Sundry Print Report

Well Name: Fuller 14/23 W1IP Fed	Well Location: T26S / R29E / SEC 14 / NESE /	County or Parish/State:
Well Number: 2H	Type of Well: CONVENTIONAL GAS WELL	Allottee or Tribe Name:
Lease Number: NMNM11038	Unit or CA Name:	Unit or CA Number:
US Well Number: 3001549317	Well Status: Approved Application for Permit to Drill	Operator: MEWBOURNE OIL COMPANY

Notice of Intent

Procedure Description: Mewbourne Oil Company requests that the following changes be made to Fuller 14/23 W1IP Fed #2H well: 1. Well name change to Fuller 14/11 W1HA Fed Com #1H. 2. BHL change to 330' FNL & 1100' FEL in Sec 23, T26S, R29E 3. Changes to directional design plot & plan corresponding to BHL change are included in sundry attachments. 4. Changes to csg program & cmt program corresponding to BHL change are included in this sundry request on page 3 & 4.

WELL LOCATION AND ACREAGE DEDICATION PLAT

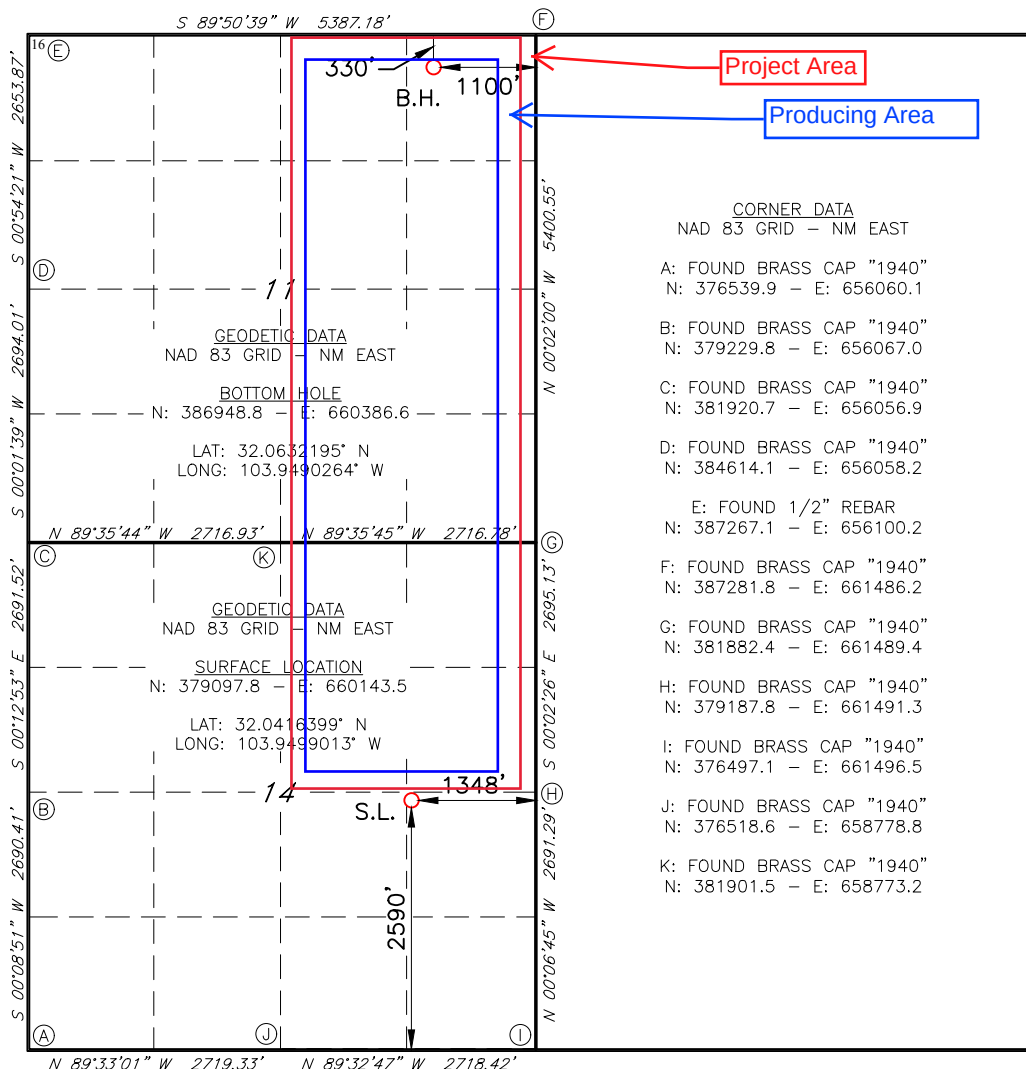
BH & NAME CHANGE 3/15/22

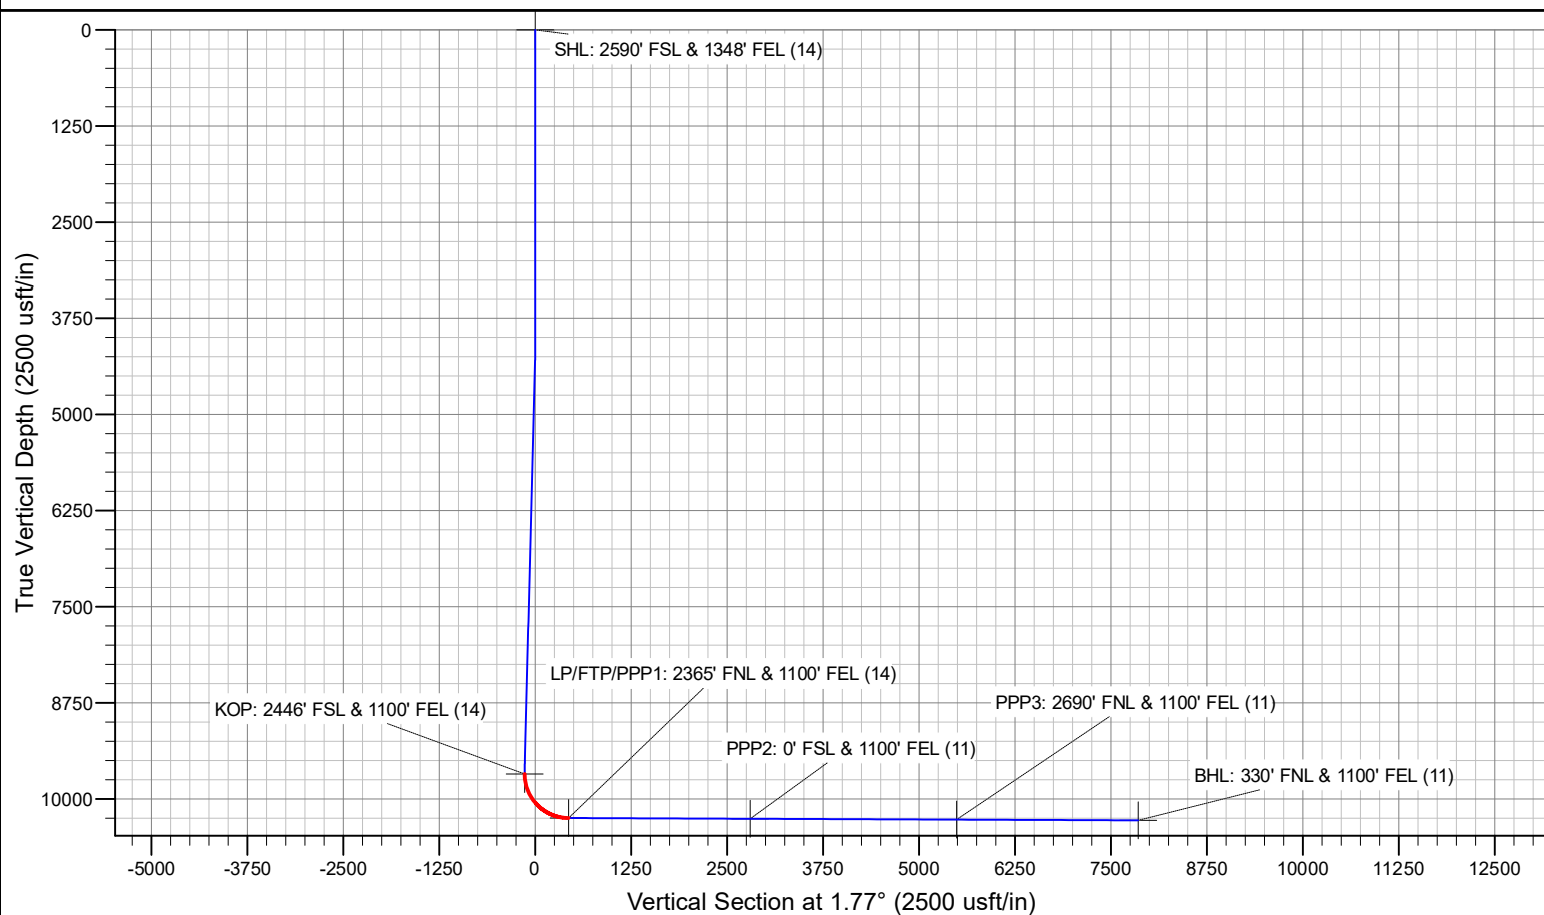
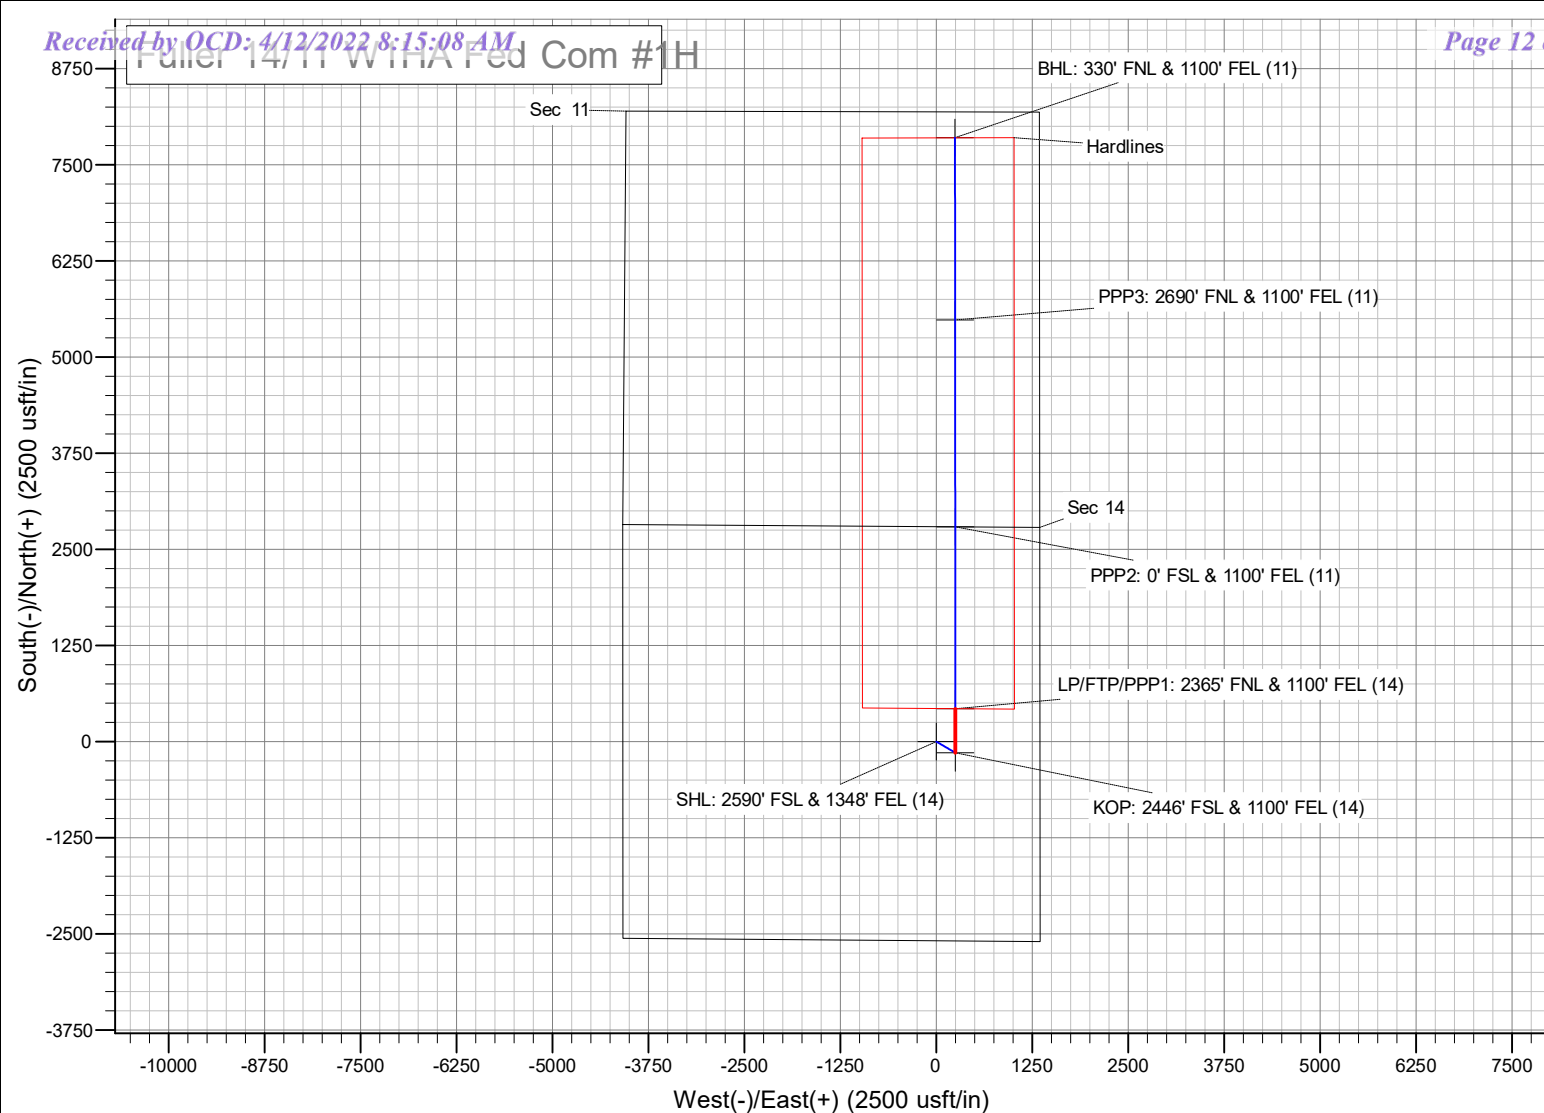
1. Well name change to Fuller 14/11 W1HA Fed Com #1H.
2. BHL change to 330' FNL & 1100' FEL in Sec 23, T26S, R29E
3. Changes to directional design plot & plan corresponding to BHL change are included in sundry attachments.
4. Changes to csg program & cmt program corresponding to BHL change are included in this sundry request on page 3 & 4.
